**LEVY NUCLEAR PLANT, UNITS 1 AND 2  
DOCKET NOS. 52-029 AND 52-030  
SUPPLEMENT 1 TO RESPONSE TO NRC RAI LETTER 114 – SRP CHAPTER 8.0,  
ELECTRICAL POWER**

**Levy Nuclear Plant Units 1 and 2 (LNP)**  
**Supplemental Response to NRC Request for Additional Information Letter No. 114**  
**Related to SRP Chapter 8.0, Electrical Power, Dated 8/14/2013**

**NRC Letter No.:** LNP-RAI-LTR-114

Figure 1: Main AC Power Station Simplified One-Line Diagram

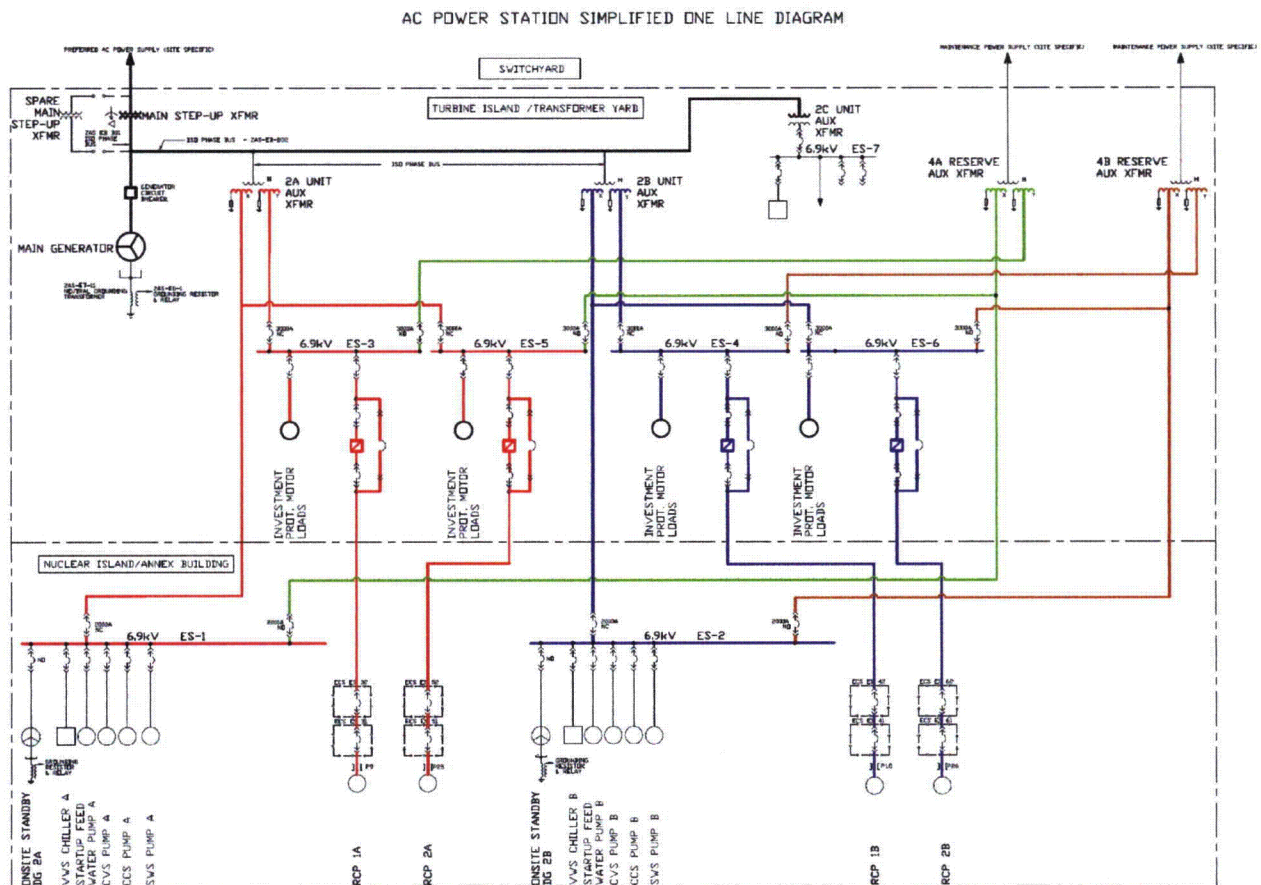
Identify which offsite circuit is credited to meet the GDC 17 requirements, considering the partial exemption for AP1000 plants.

The credited GDC 17 offsite power supply for the AP1000 plant is the Preferred AC Power Supply shown in Figure 1. The Preferred AC Power Supply is backfed through the three single phase main step-up transformers (MSUs), labeled "MAIN STEP-UP XFMR" as shown on Figure 1. The Preferred AC Power Supply is connected to the main generator bus and through the unit auxiliary transformers (UATs) 2A and 2B to the plant electrical distribution system.

Because of its passive safety features, the AP1000 passive plant does not require AC power to place the plant in a safe, stable shutdown condition. The AP1000 design was granted a partial exemption from GDC 17, specifically exempting the AP1000 plant from the requirement for a second GDC 17 credited offsite power source. Therefore, a second credited source of AC power from the power grid is not required. The Onsite Standby Power System (ZOS), powered by onsite standby diesel generators 2A and 2B, provides an alternate source of AC power to the plant electrical distribution system through medium voltage buses ES-1 and ES-2 for defense-in-depth shutdown loads.

Because of the partial GDC 17 exemption, the Maintenance Power Supply, fed through reserve auxiliary transformers (RATs) 4A and 4B, is not considered a credited GDC 17 power source. However, the medium voltage buses ES-1 and ES-2 can be manually aligned to receive power through the RATs. The medium voltage buses will automatically transfer from the UATs to the RATs in the event the credited Preferred AC Power Supply becomes unavailable due to an electrical fault at either the MSU, the isophase bus, the UATs or the 6.9 kV nonsegregated bus duct.
